Landmark Environmental LLC

September 18, 2007

**Re: VRAP, ECP, & Design Modifications Submittal
219 and 223 First Avenue S.W., Rochester, MN
VP12562**

DUAL PHASE EXTRACTION SYSTEM LAYOUT
219 AND 223 FIRST AVENUE S.W.
ROCHESTER, MINNESOTA

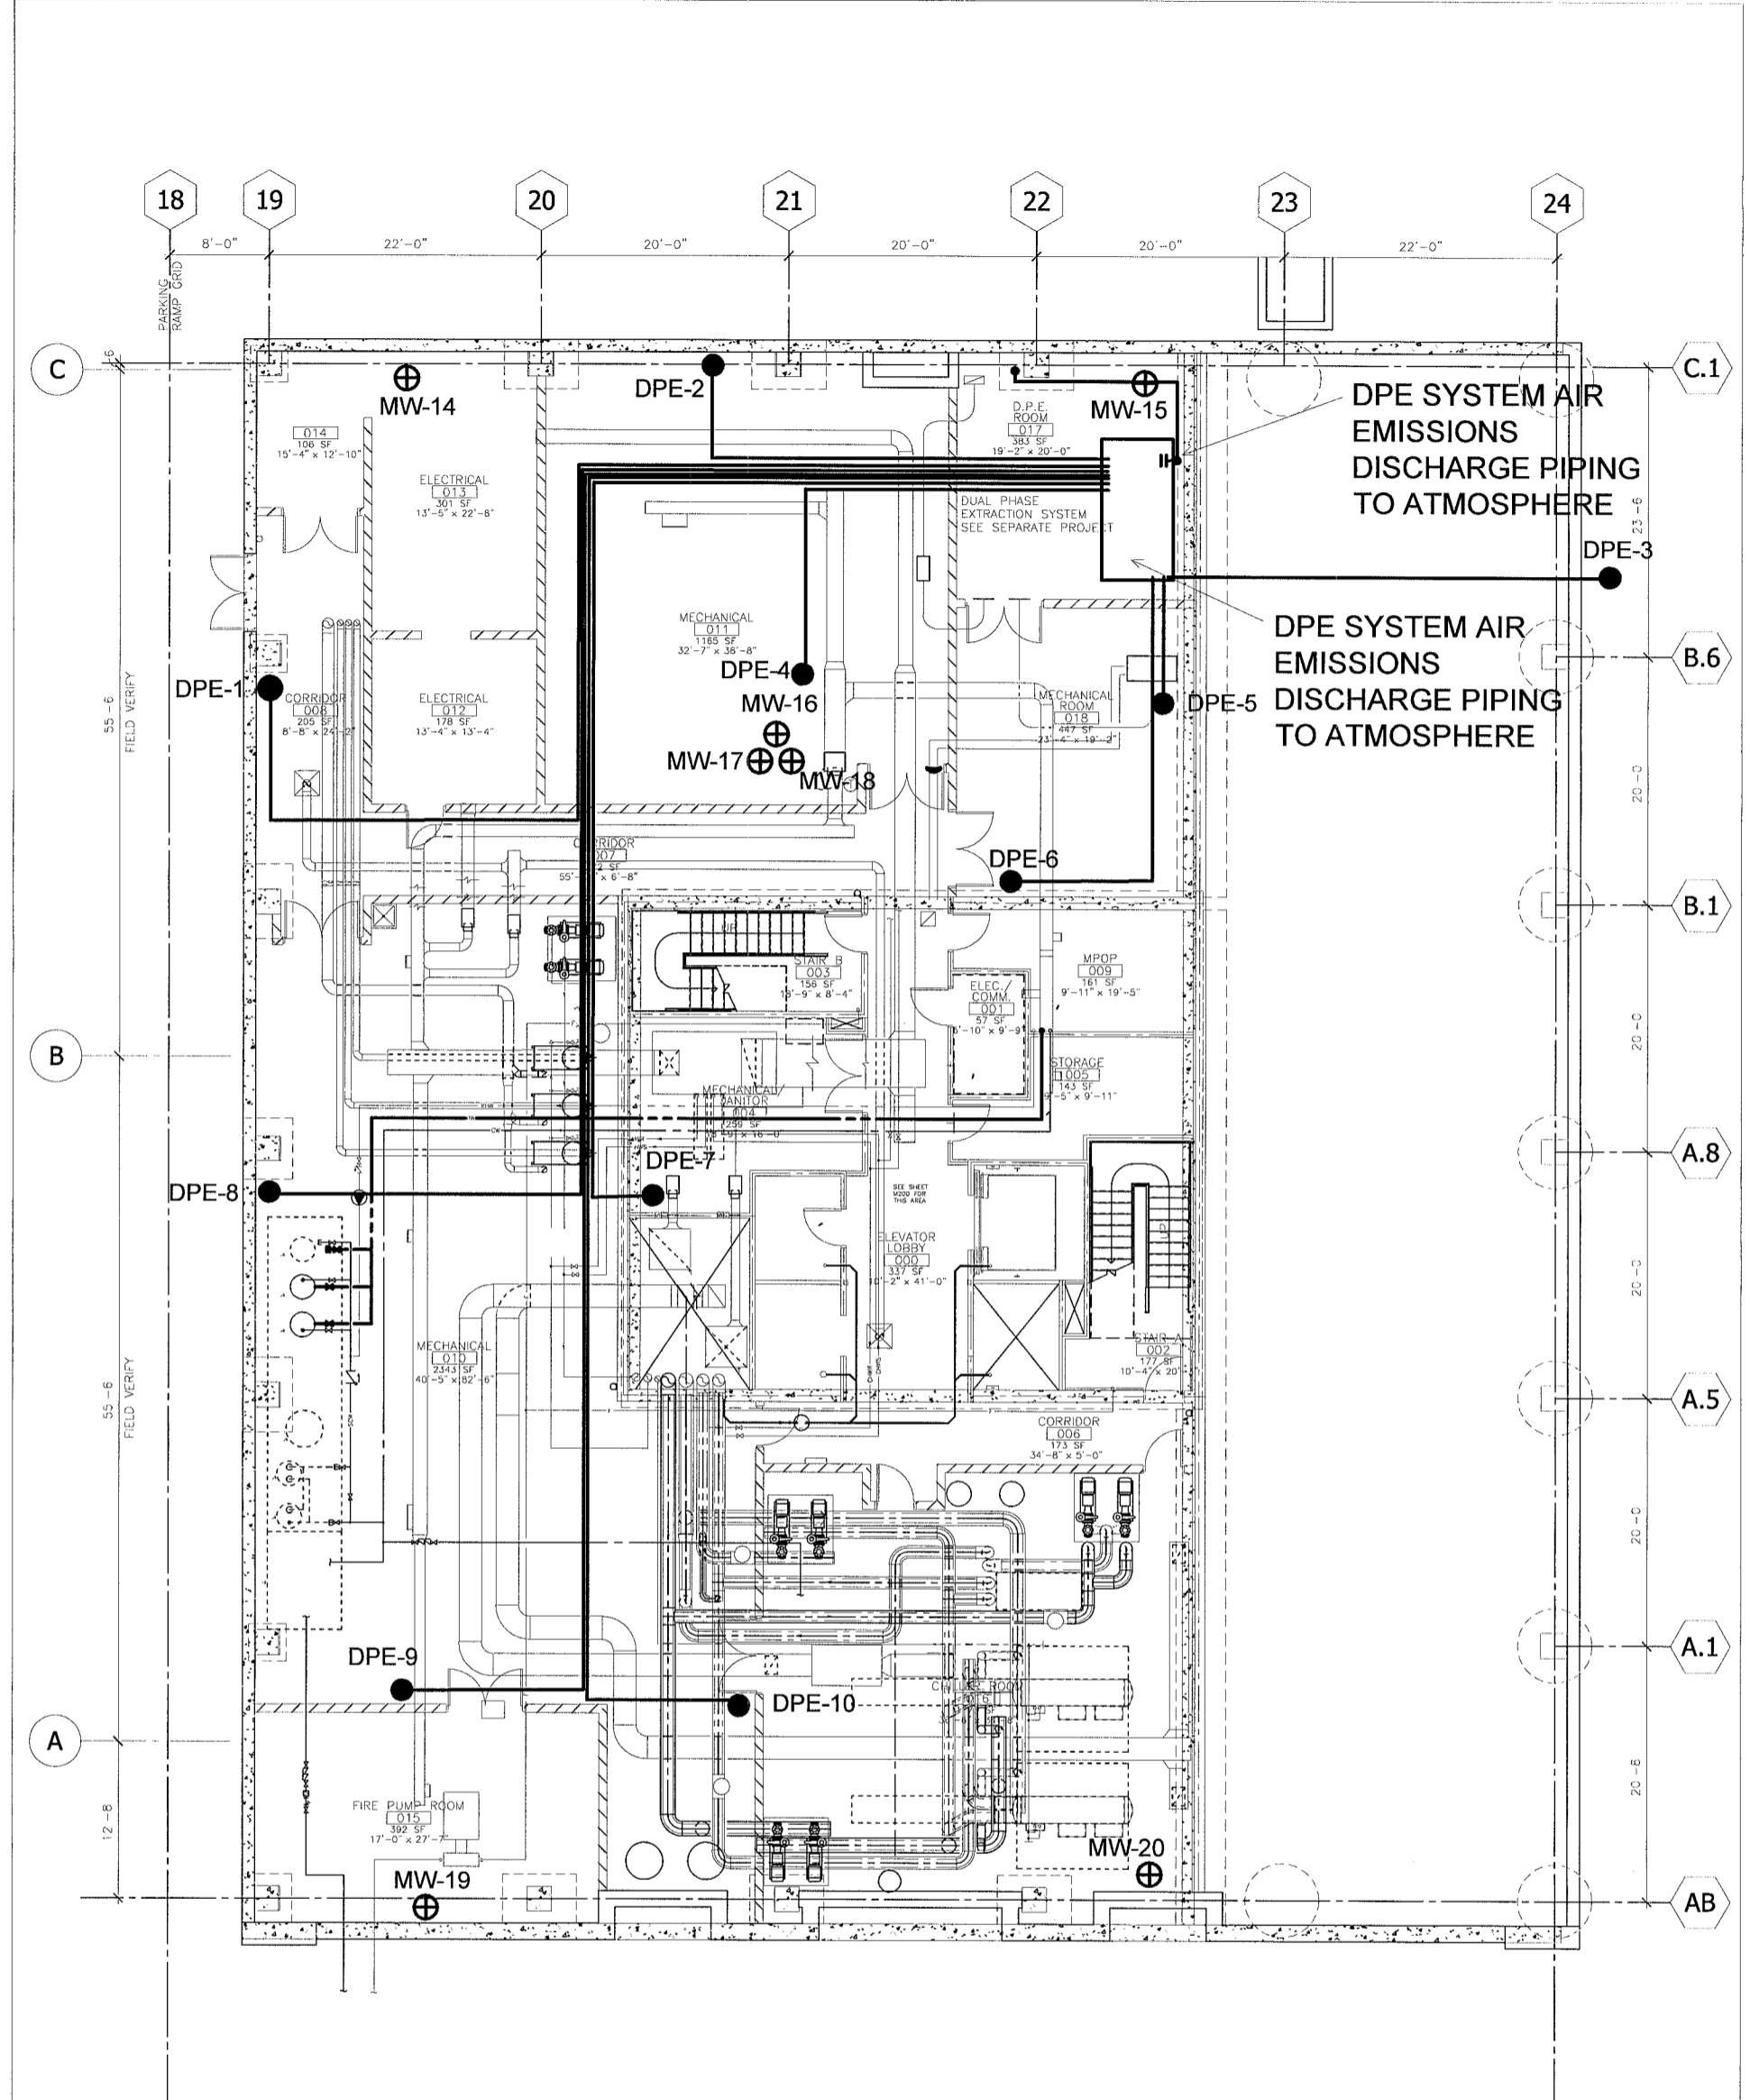
- The depths and screen intervals of the proposed DPE extraction wells and monitoring wells are included in Attachment 4.
- A discharge permit from the City will be obtained to dispose of groundwater generated by the DPE system. The maximum allowable concentration of total VOCs for discharge to the City Reclamation Plant is 2.13 milligrams per liter. Groundwater discharge sampling analysis will be completed as required under the discharge permit.

- The DPE system will be designed to remove source area perchloroethene (PCE) from the soil and fractured bedrock, resulting in decreasing concentrations of PCE in the groundwater. The DPE system operational goals include achieving asymptotic PCE air exhaust concentrations, and achieving asymptotic mass removal quantities of PCE. The DPE wells will be operated to maximize the amount of PCE removed from the subsurface. The proposed cleanup goal for the groundwater is to reduce the source of PCE to the groundwater. DPE system success will be determined by asymptotic air emissions of PCE, and decreasing groundwater concentrations. Quarterly groundwater monitoring will begin during DPE system startup activities and continue as long as the DPE system is operational. After the MPCA approves decommissioning of the DPE system, groundwater will be monitored quarterly, at a minimum, for a period of one year after the date of DPE system shut-down.

- An updated DPE system layout drawing is included in Attachment 3.

VAPOR BARRIER AND PASSIVE VENTING SYSTEM DETAILS
219 AND 223 FIRST AVENUE S W
ROCHESTER, MINNESOTA

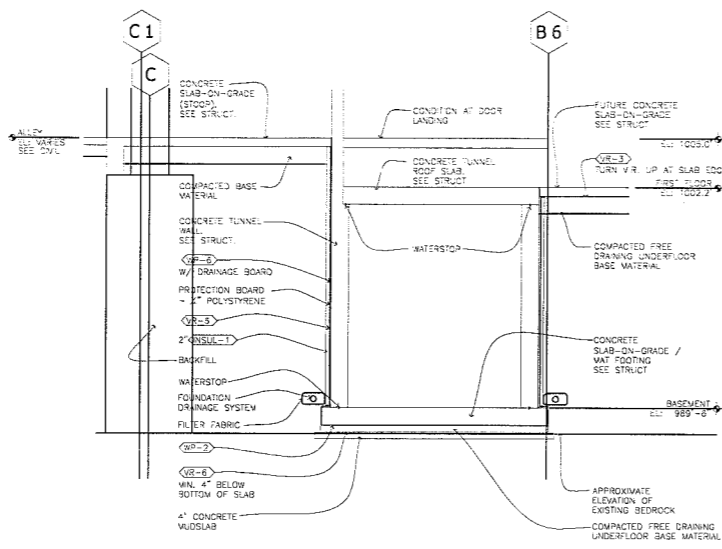
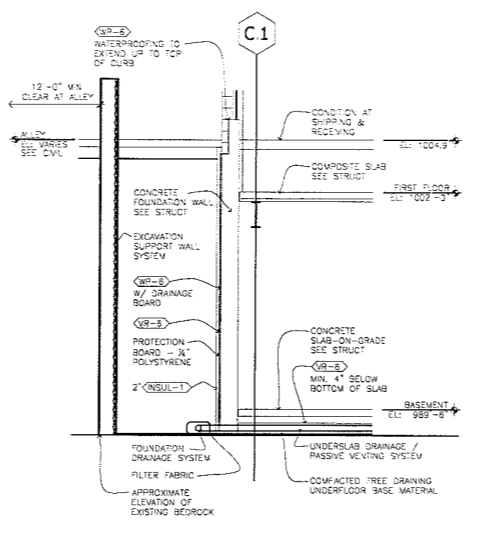
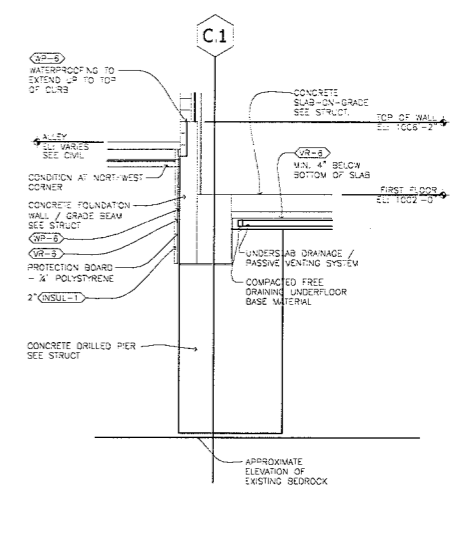
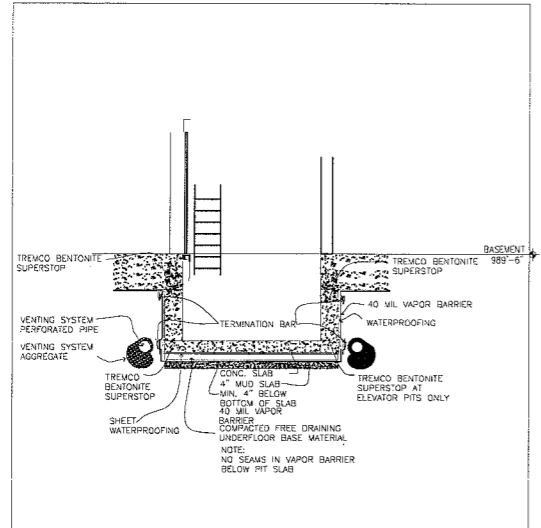
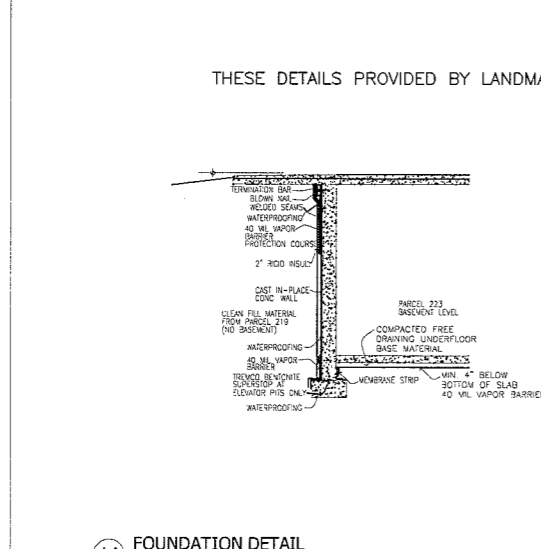
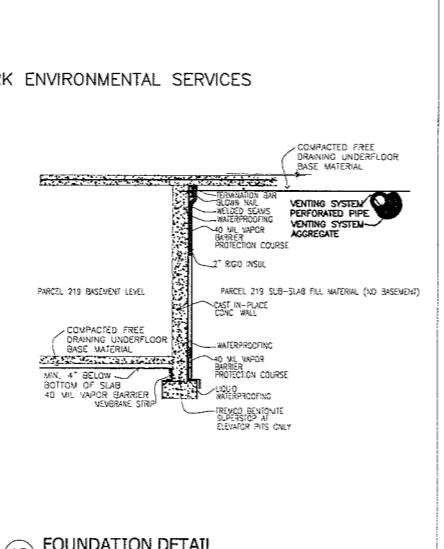
- The vapor barrier material proposed for the project has been changed to a 40-mil thick polyethylene barrier with protrusion boots, and thermally welded seams. In addition, any barrier joints/seams, both lateral and butt, shall be overlapped at least 12 inches and in accordance with manufacturer's recommended seam completion and testing procedures. Vapor barrier performance, installation, and serviceability assurance details are included in the specification Section 072623, Below-Grade Gas Retarder. Section 072623 is included in Attachment 3 and replaces specification Section 02666, Vapor Barrier, previously submitted to the MPCA by Landmark in the VRAP Addendum – Response Action Design, dated July 17, 2007.

- Updated design drawings, detail drawings, and specifications for the foundation drainage/venting system are included in Attachment 3. Revisions to the specifications include designing the exhaust stack outlets to be located at least 10 feet from any building openings or any public or private access area. The venting system has been configured such that any subsequent upgrade can be made to accommodate an in-line fan for "active service" mode.

- The selected sub-floor vapor barrier shall be at least a 40-mil thick barrier with protrusion boots. All seams will be thermally welded. Provide VIC staff vapor barrier performance, installation and serviceability assurance details; The RAP, Attachment 6, Division 1 & Division 2 Specifications - Section 02666, Vapor Barrier, needs significant modification.

BASEMENT LEVEL SUB-SLAB - FOUNDATION VENTING AND DRAINAGE SYSTEM
 219 AND 223 FIRST AVENUE S.W.
 ROCHESTER, MINNESOTA

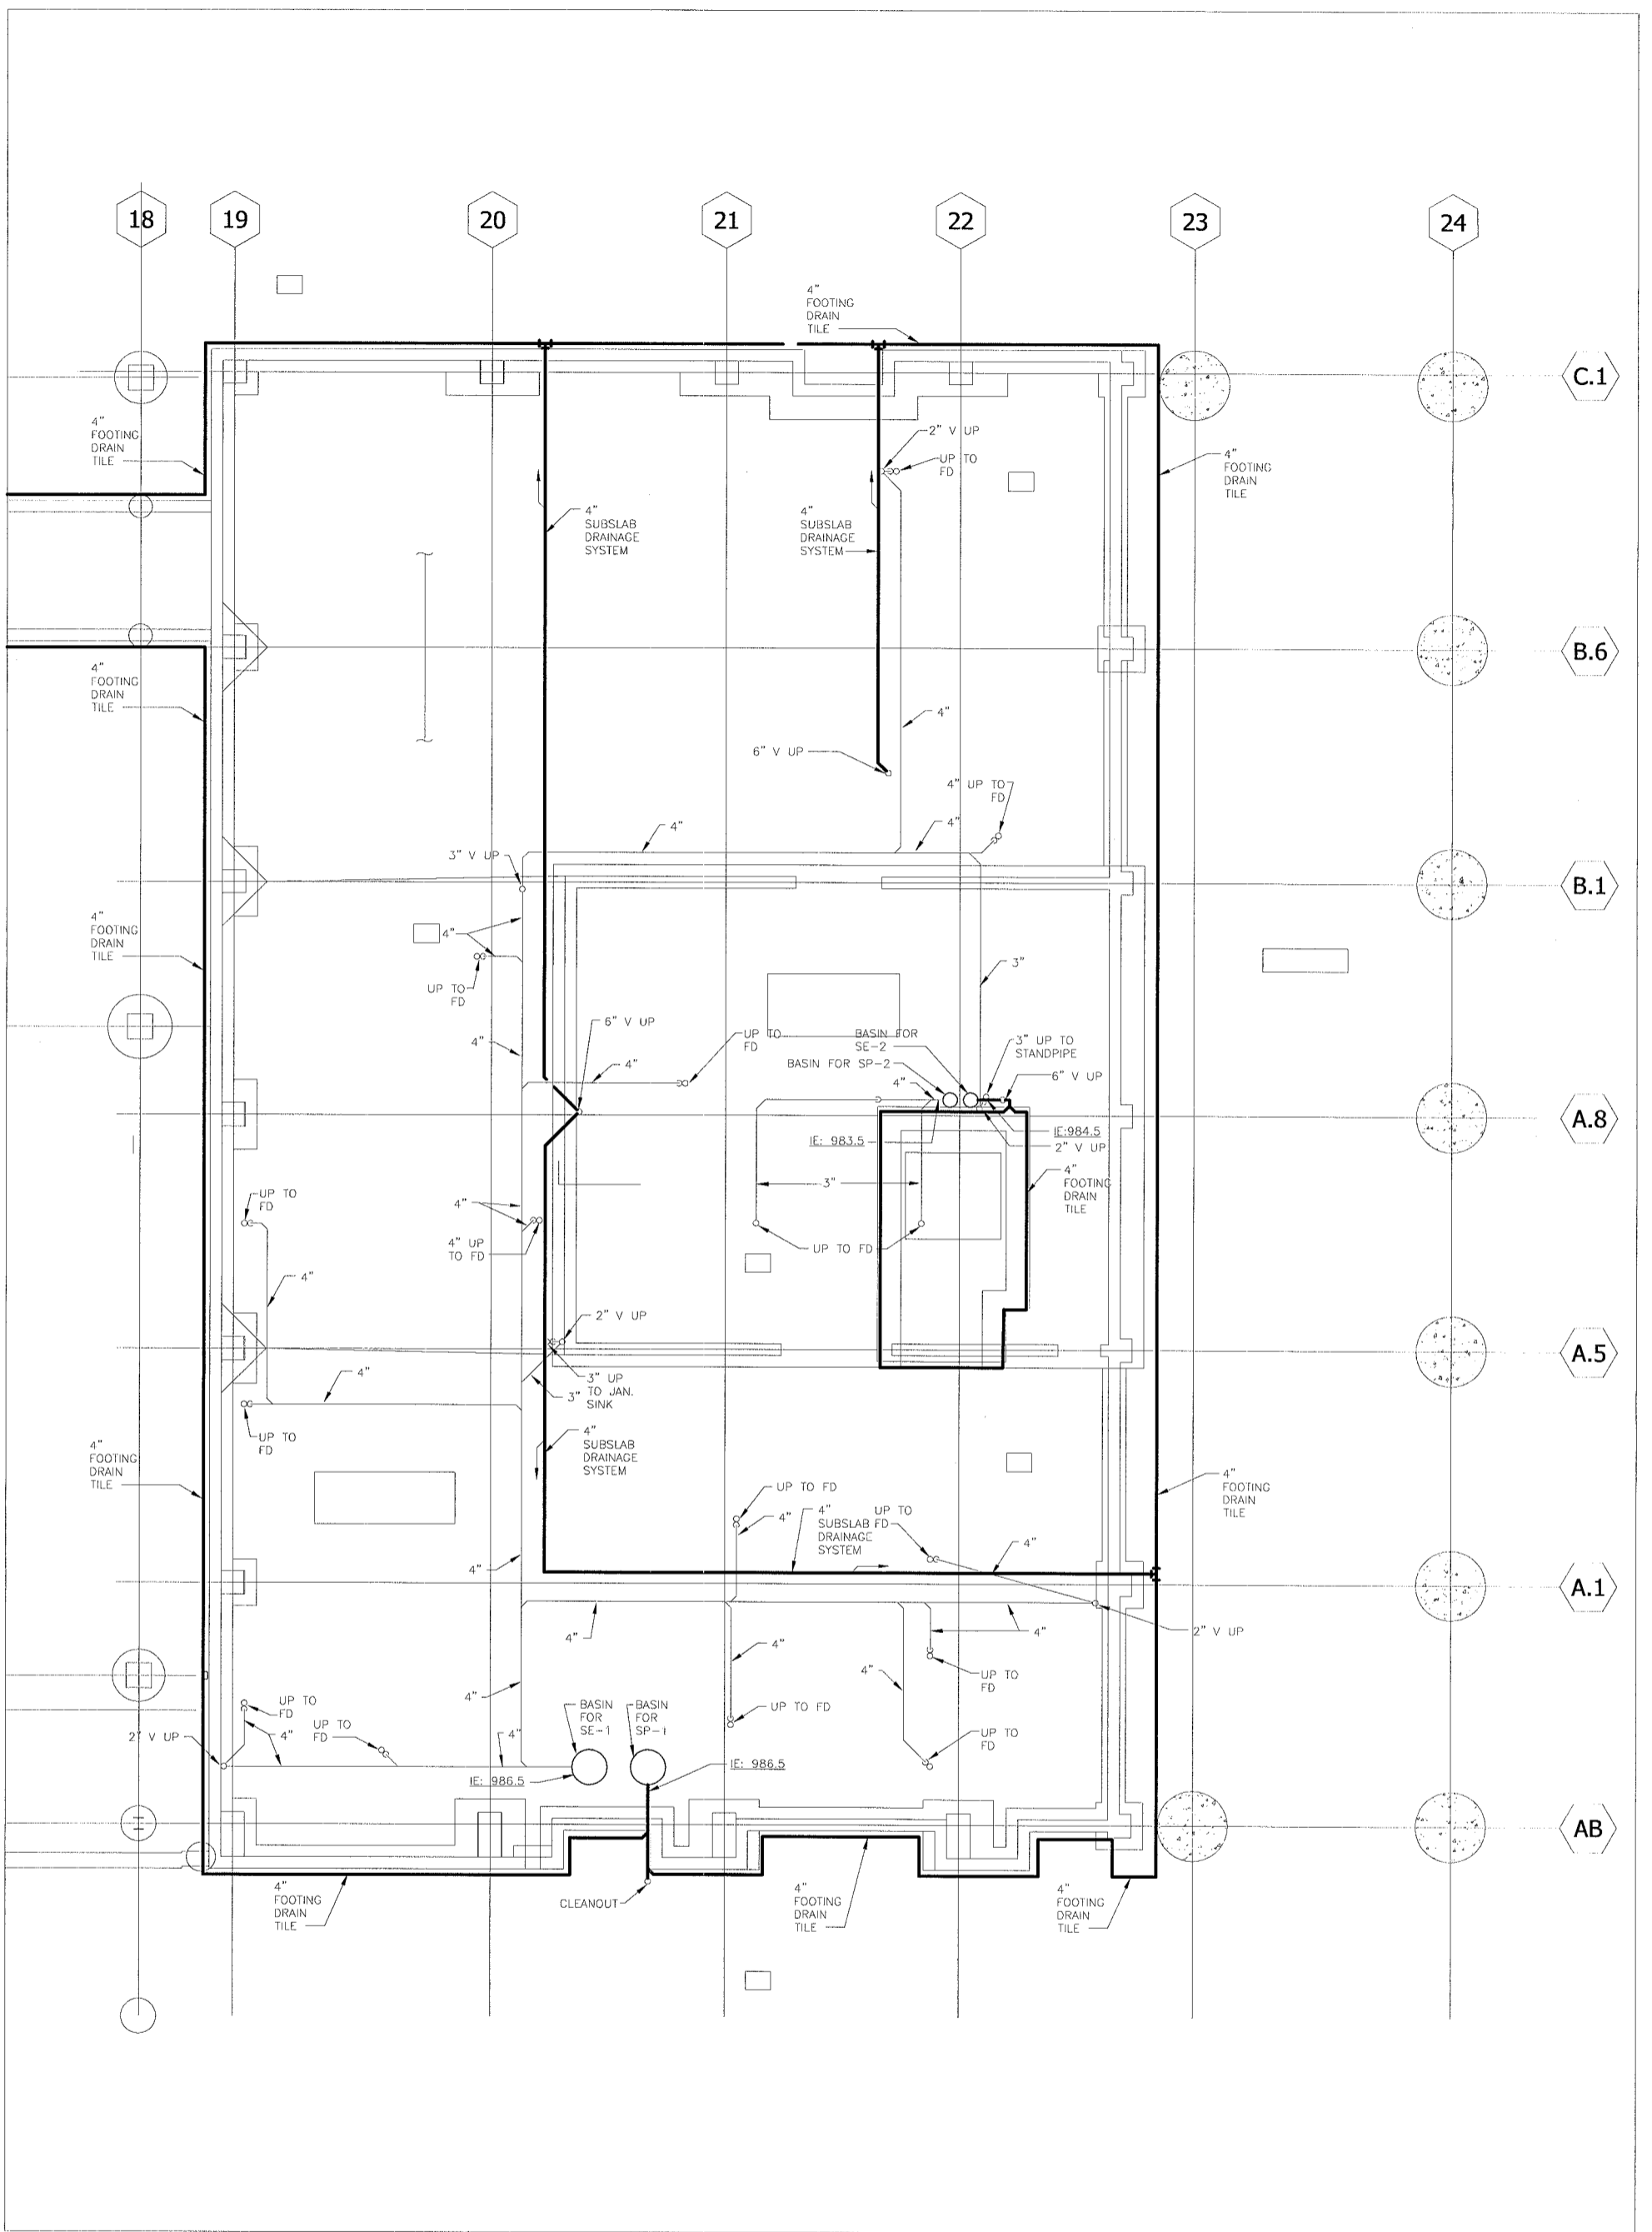
- The geotechnical engineer for the project (McGhie & Betts) recommended a foundation drainage system at the Property; therefore, the sub-slab vent piping was designed to also be utilized as the drain tile as shown on the design drawings. Because the venting system is designed to utilize the drain tile, the sub-slab piping is designed to slope such that groundwater drains to the storm sewer. As discussed in the Sub-Slab Venting System Monitoring Plan, included in Attachment 3, the performance of the venting system will be evaluated to determine the effectiveness of the rotary wind turbines to maintain airflow from the subsurface to the atmosphere. If it appears that the sloping of the sub-slab piping is inhibiting the effectiveness of the rotary wind turbines to operate successfully, in-line fans will be installed in the venting system riser pipes for "active" service mode.

- The sub-slab venting system will be operated in the "closed" position until the dual-phase extraction system is permanently decommissioned as approved by the MPCA. At this time, the venting system shut-off valves will be opened to initiate "passive" sub-slab venting of the building. The

- Provide VIC staff additional sub-slab venting system details including slope of horizontal piping runs toward intake risers (not "storm sewer" as in Attachment 6, Section 02667), and how the system will be maintained as in a valve "open", passive venting condition;
